HISTORIC AND DESIGN REVIEW COMMISSION

HDRC CASE NO: 2020-451

ADDRESS: 204 W GRAMERCY PLACE

REQUEST:

SHEET TITLE 2ND FLOOR DEMO/NEW PLAN

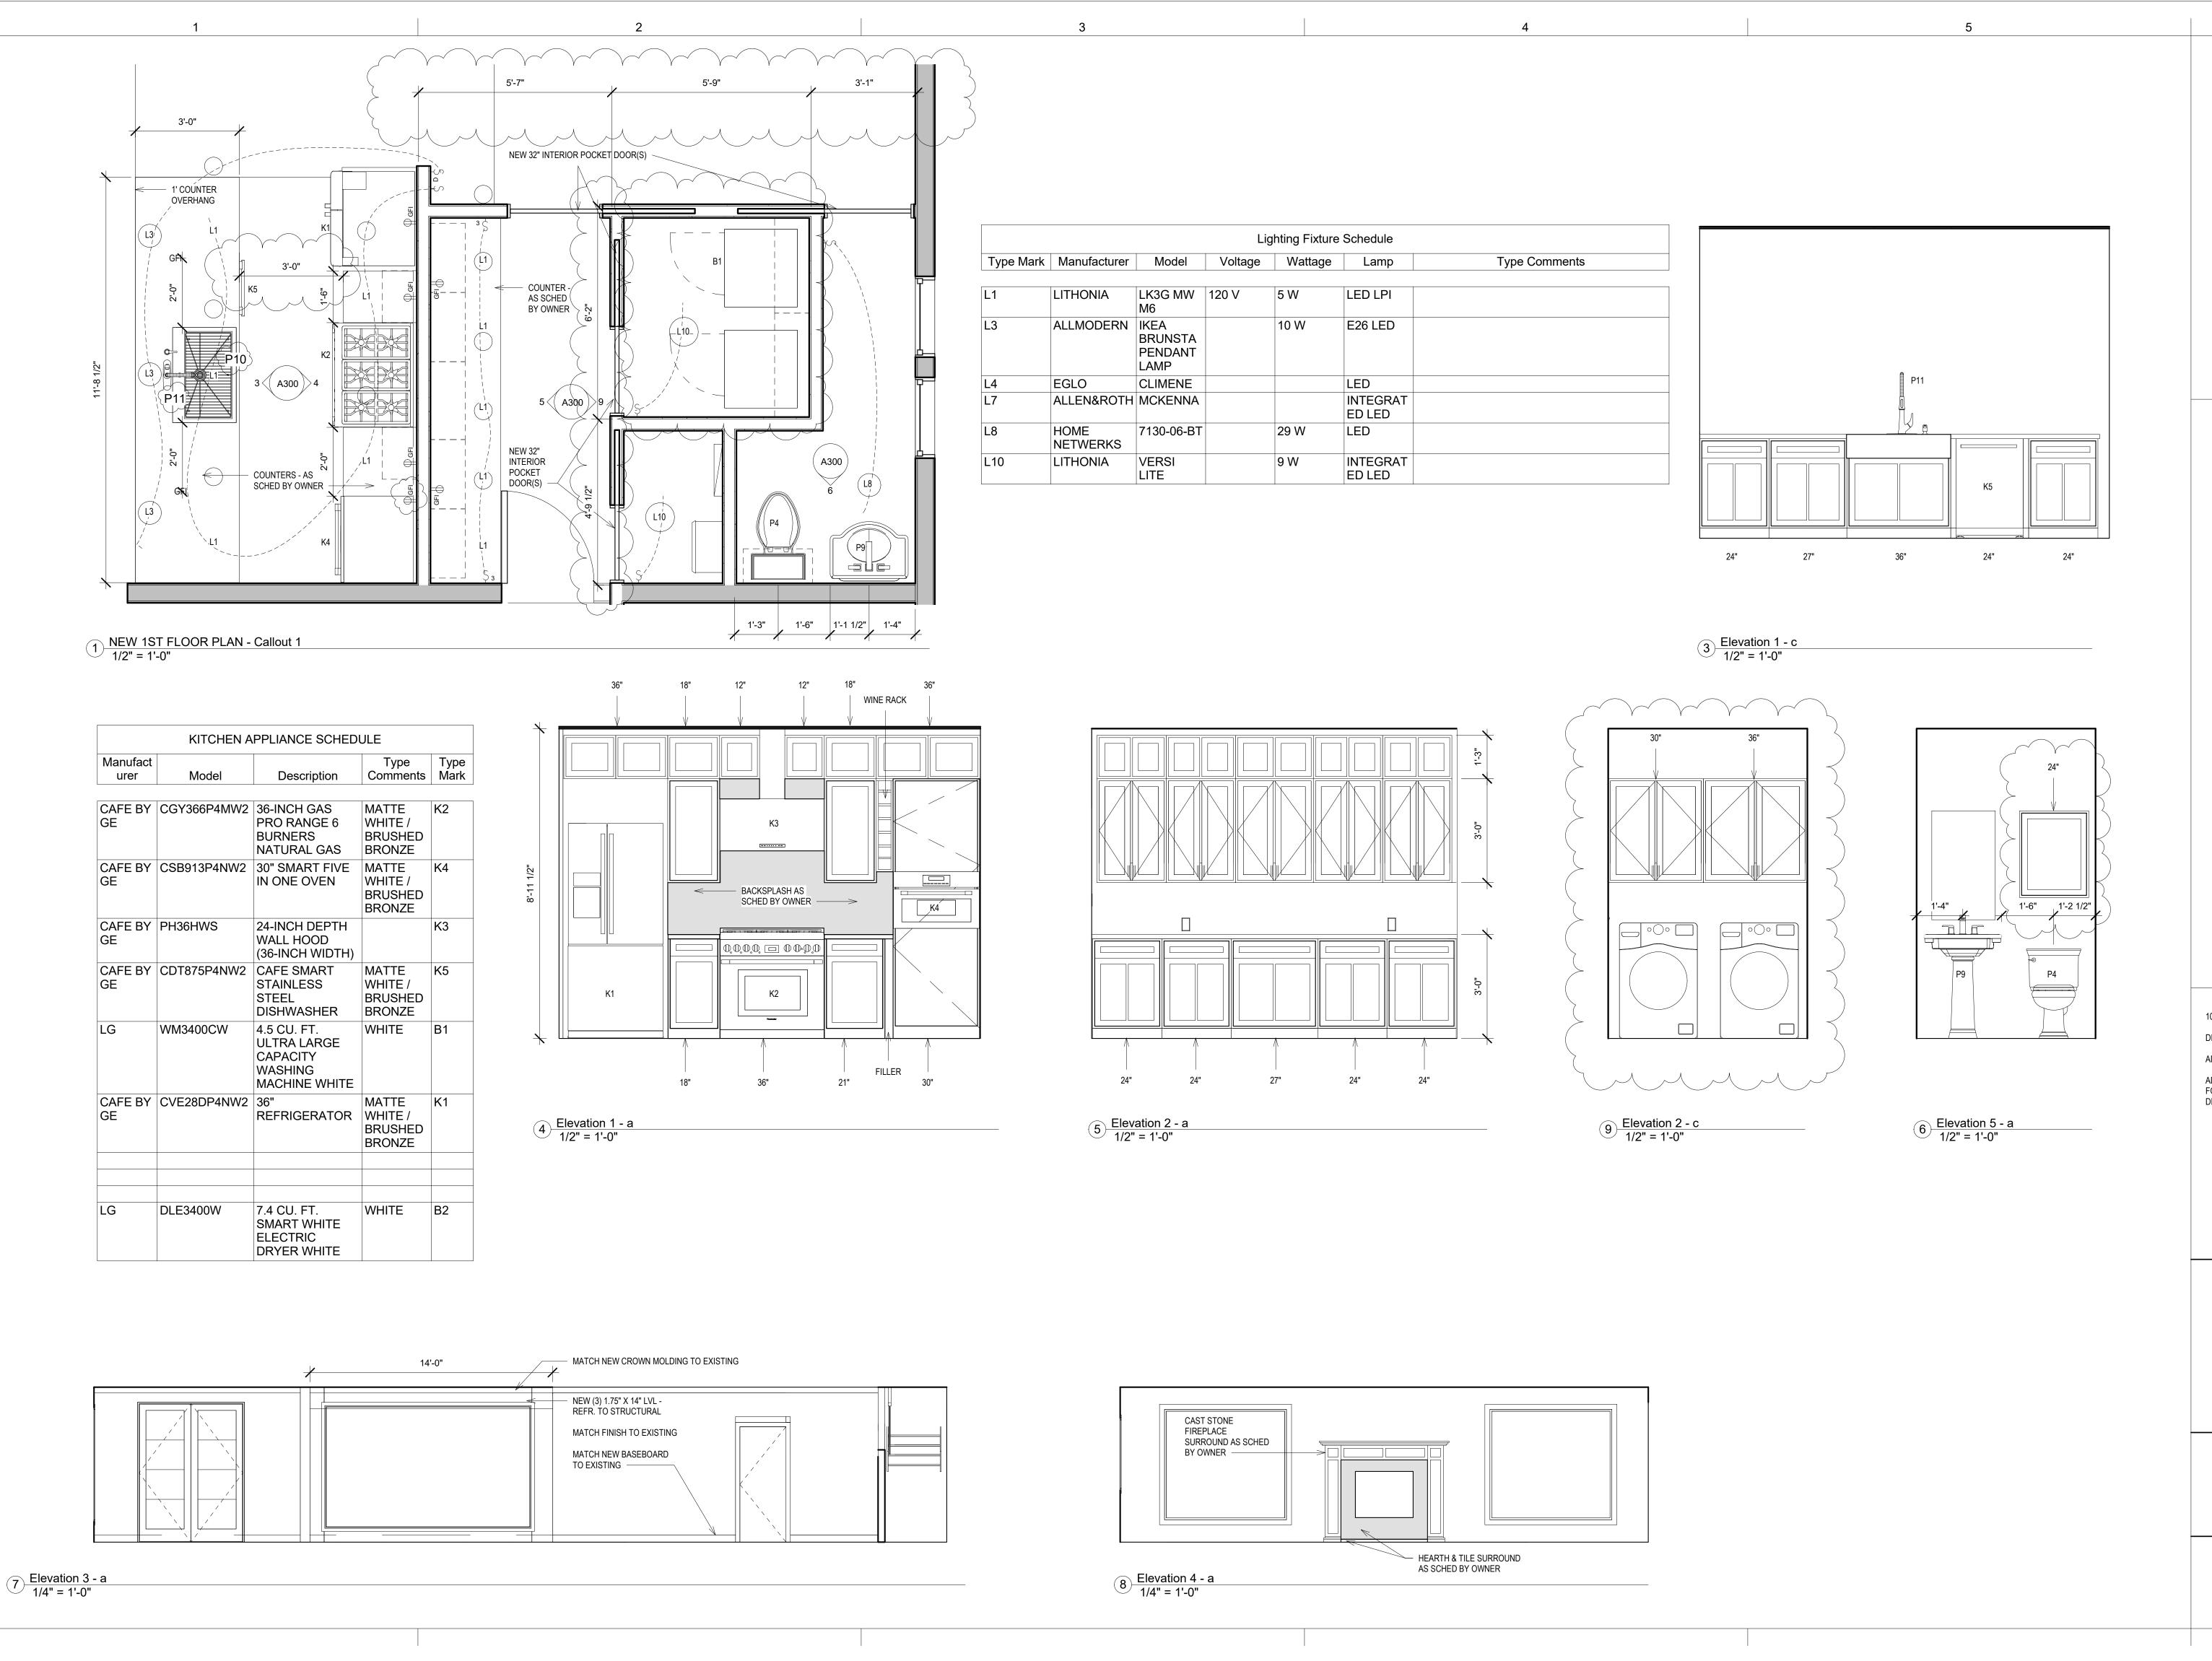
- b. FENESTRATION MODIFICATIONS: FRENCH DOORS TO WINDOW— The applicant has proposed to replace two sets of existing French doors that are located in the center of the rear façade beneath a deep-set rear porch with a 144"x86" picture window. The existing French doors are set in 30" openings. The applicant has proposed to install a fully wood Pella Architect Series double pane picture window with Low-E glass. The window will be painted to match existing doors. Guideline 6.A.i for Exterior Maintenance and Alterations states that existing window and door openings should be preserved. Avoid creating new primary entrances or window openings on the primary façade or where visible from the public right-of-way. Guideline 6.A.ii for Exterior Maintenance and Alterations states that historic doors, including hardware, fanlights, sidelights, pilasters, and entablatures should be preserved. Staff finds that the existing openings should be preserved, and that the historic fenestration pattern should be preserved. Staff finds that a request to install windows in the existing door openings would be appropriate. The installation of a new window opening between the two existing door openings is more consistent with the Guidelines and will provide symmetry with the existing fenestration pattern on the west side of the rear elevation.

- c. FENESTRATION MODIFICATION: ALCOVE ENCLOSURE The applicant has proposed to remove the existing fixed window on the west side of the rear elevation, enclose the alcove to meet the existing rear wall and place the existing glazed door in the new exterior wall, which features two sets of French doors that the applicant is not proposing to modify. Guideline 6.A.i for Exterior Maintenance and Alterations states that applicants should avoid filling in historic door or window openings. Staff finds that the existing openings are likely not original to the structure and the alcove enclosure will not result in a loss of character. Staff finds the proposal appropriate.

- d. FRENCH DOOR REPLACMENT The applicant has proposed to replace an existing set of 48" rear French doors with a set of fully wood 72" x 96" French doors. According to Guideline 6.A.i for Exterior Maintenance and Alterations, existing door openings should be preserved. The applicant has indicated that this portion of the house is an addition and staff finds that the existing opening has been previously modified. Staff finds the proposal appropriate.

- i. That the applicant installs windows in the existing door openings and installs a new window between the existing openings to create a bank of three windows in lieu of the proposed picture window. The applicant is required to submit updated elevation and detail drawings to staff prior to the issuance of a Certificate of Appropriateness
